Final Drainage Report for Church at Bent Grass Meadows

PCD File No. SF268

EPC STORMWATER REVIEW COMMENTS
IN ORANGE BOXES WITH BLACK TEXT

Concrete Rundown Basin A3 - 100-Yr WSEL

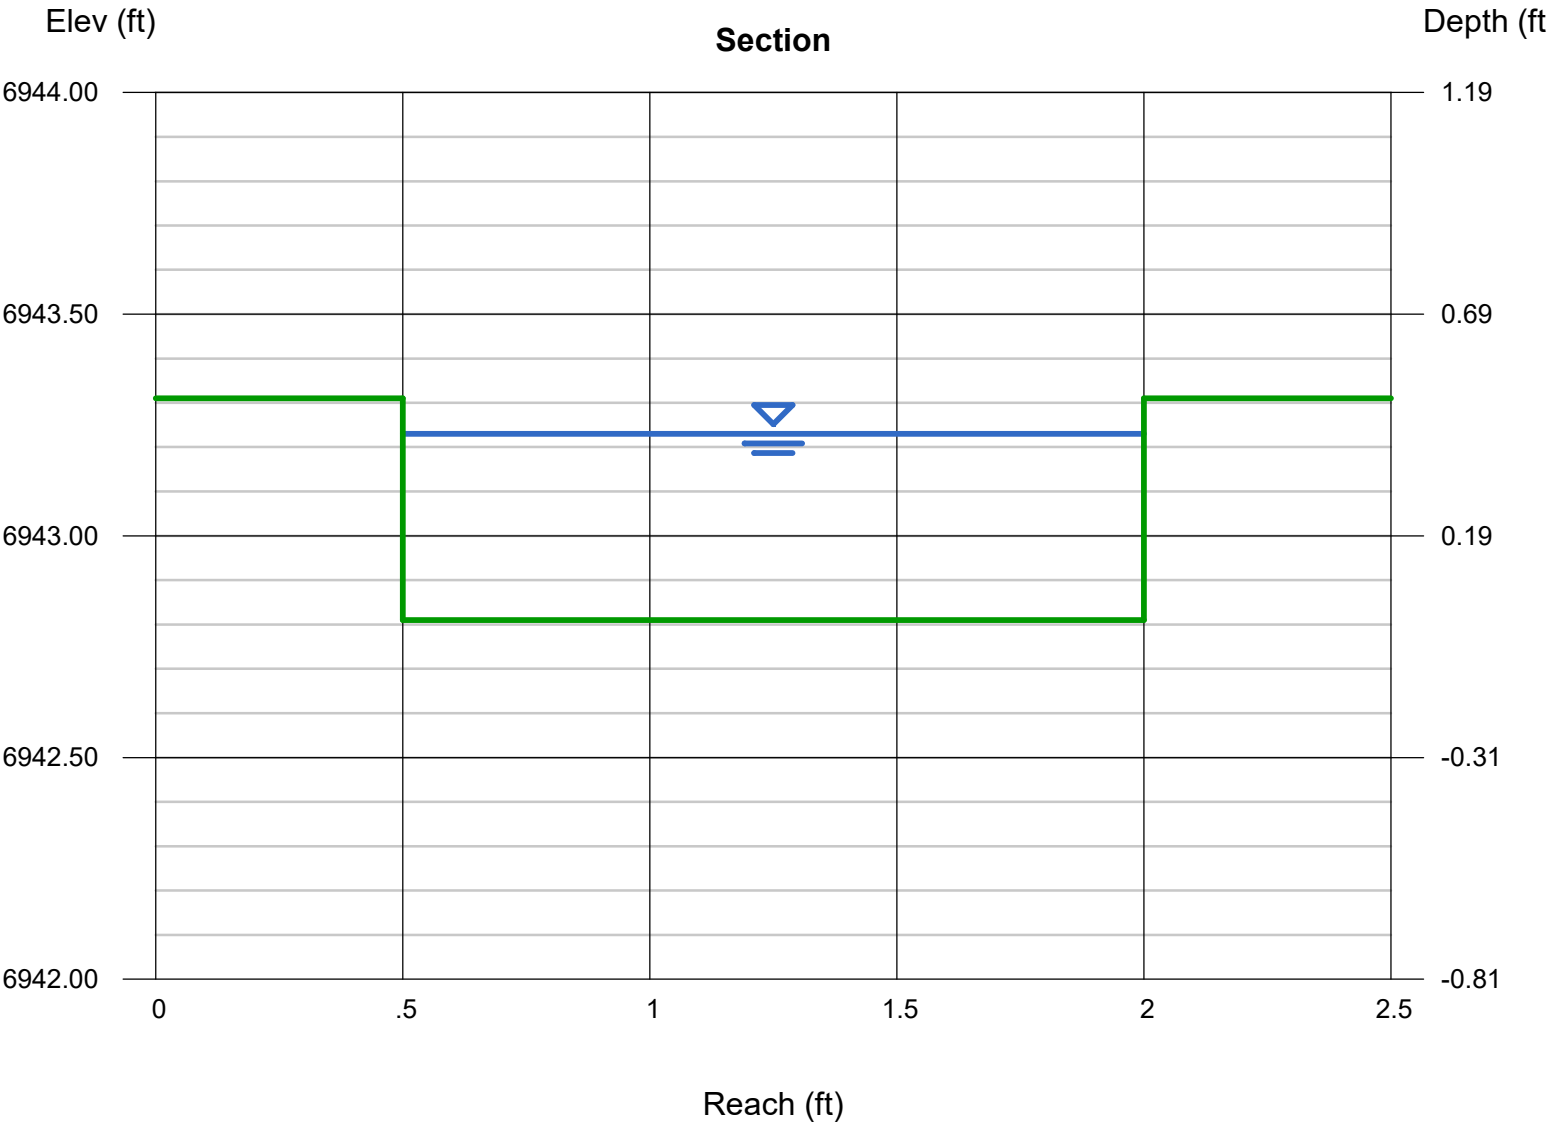
Rectangular		Bottom width is 2.50' on Sheet PCM 6 of CDs. Please revise.	Highlighted	
Bottom Width (ft)	= 1.50		Depth (ft)	= 0.42
Total Depth (ft)	= 0.50		Q (cfs)	= 2.430
Invert Elev (ft)		= 6942.81	Area (sqft)	= 0.63
Slope (%)		= 0.50	Velocity (ft/s)	= 3.86
N-Value		= 0.011	Wetted Perim (ft)	= 2.34
Calculations			Crit Depth, Yc (ft)	= 0.44
Compute by:		Known Q	Top Width (ft)	= 1.50
Known Q (cfs)		= 2.43	EGL (ft)	= 0.65

Middle Tributary Bent Grass Meadows Crossing - Max Capacity

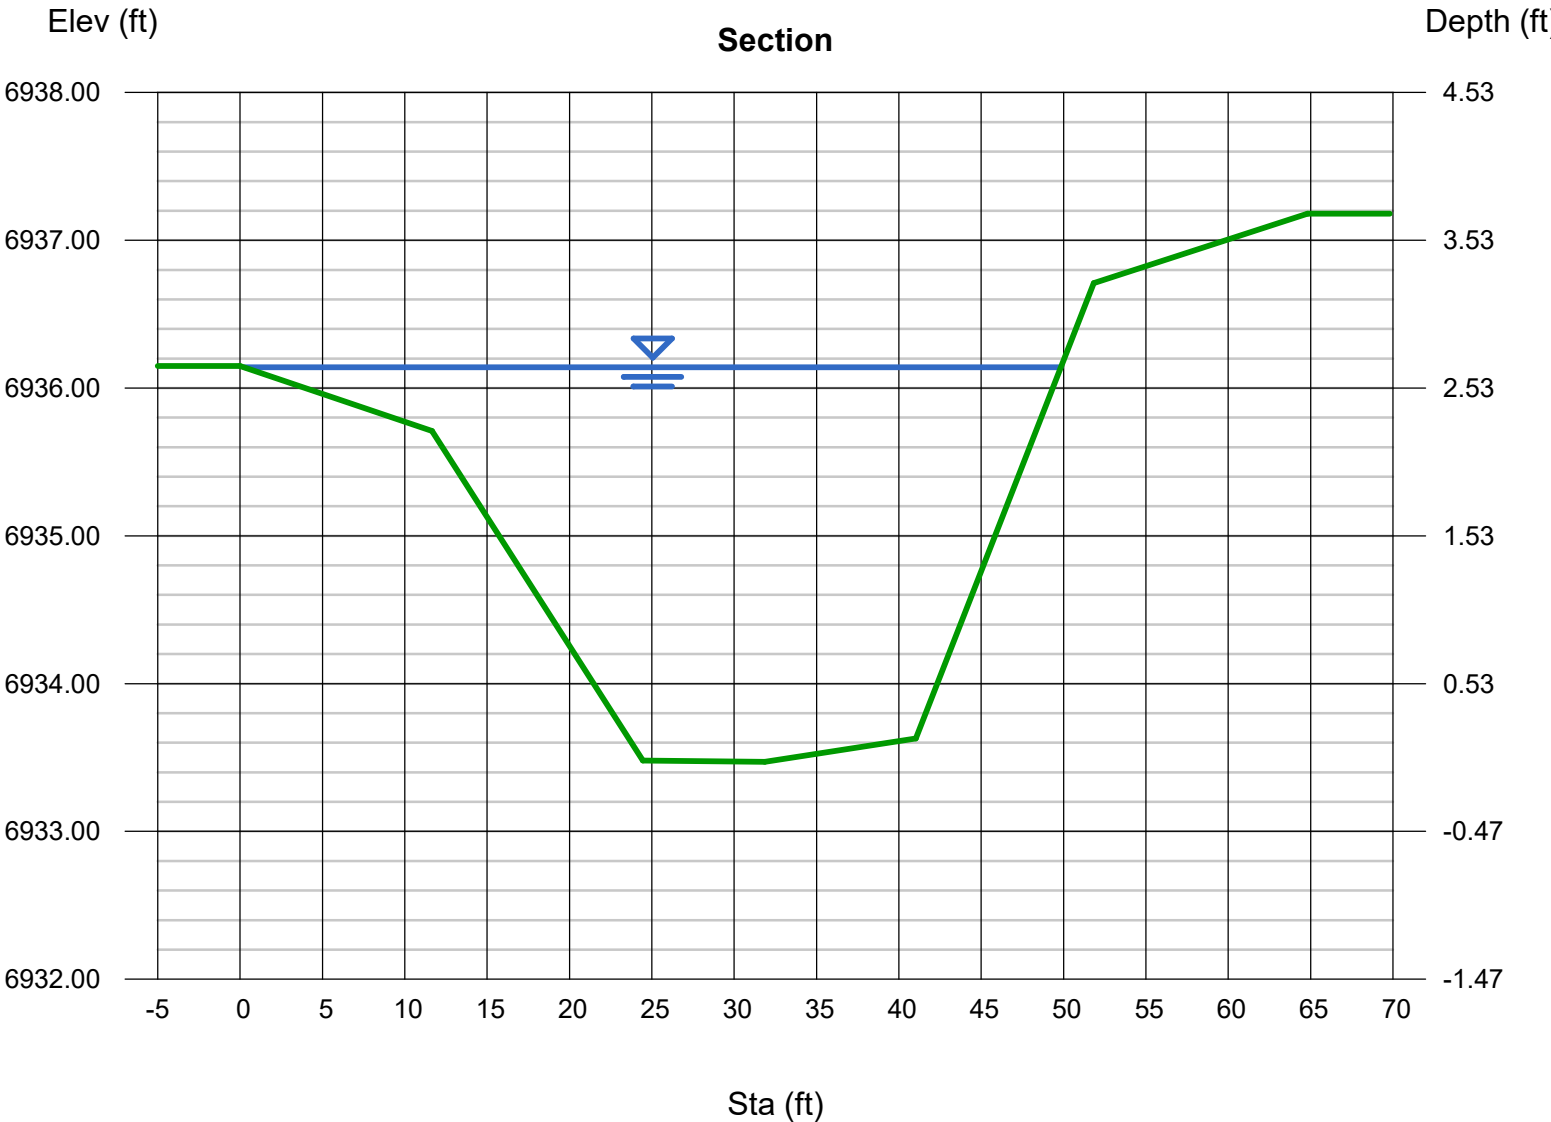
Please specify how this flow rate was determined and identify the source of the value.

DETENTION BASIN OUTLET STRUCTURE DESIGN

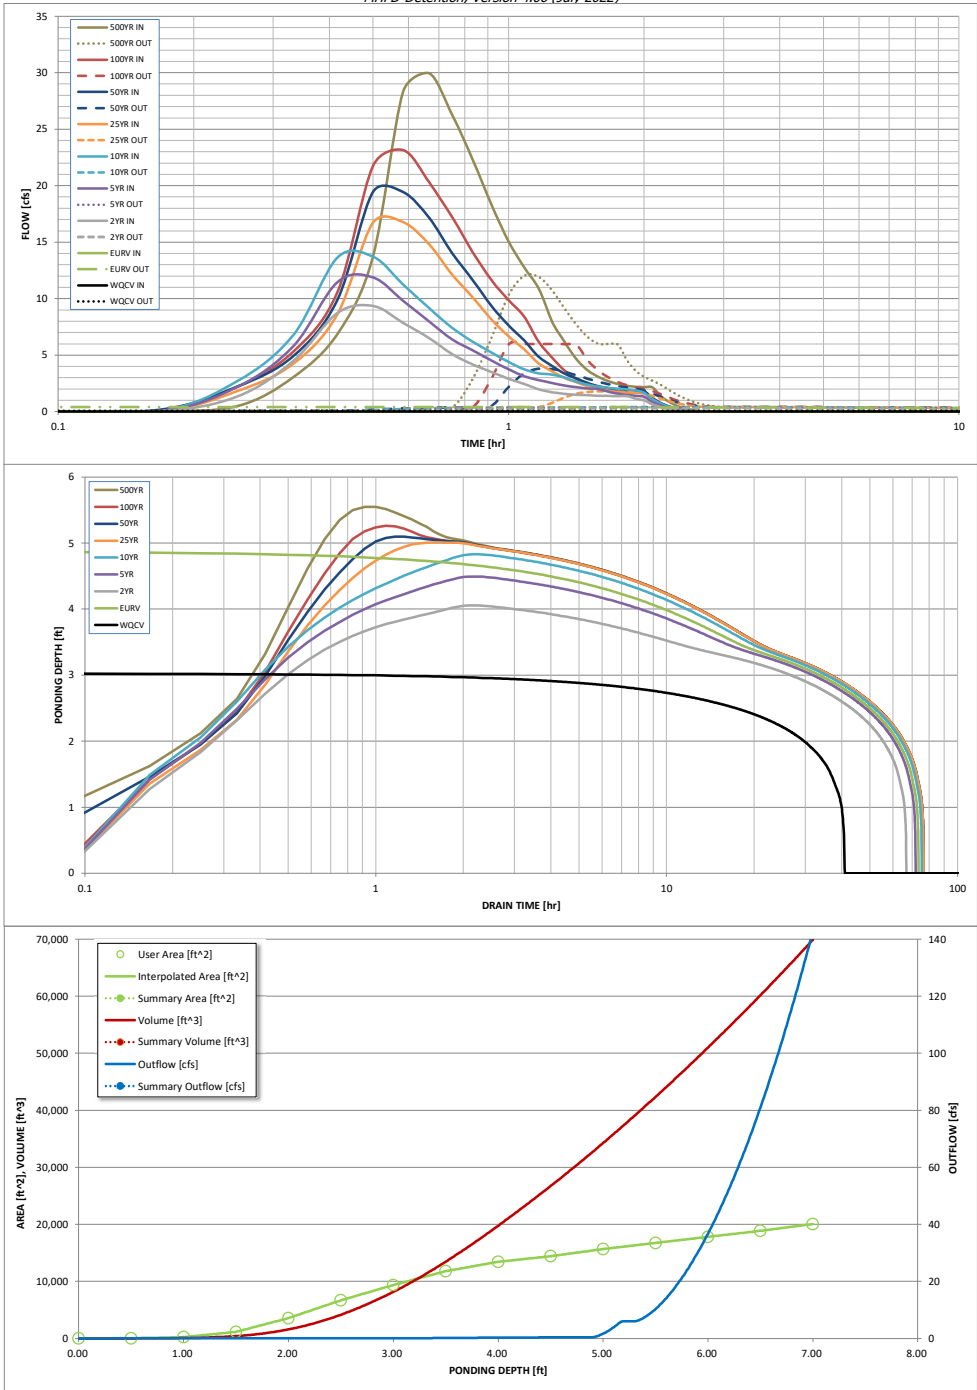
plans call out 5:1

Explain why these are overridden in the text and add a note

Please discuss in narrative why 1.0 could not be achieved and that impacts are negligible.
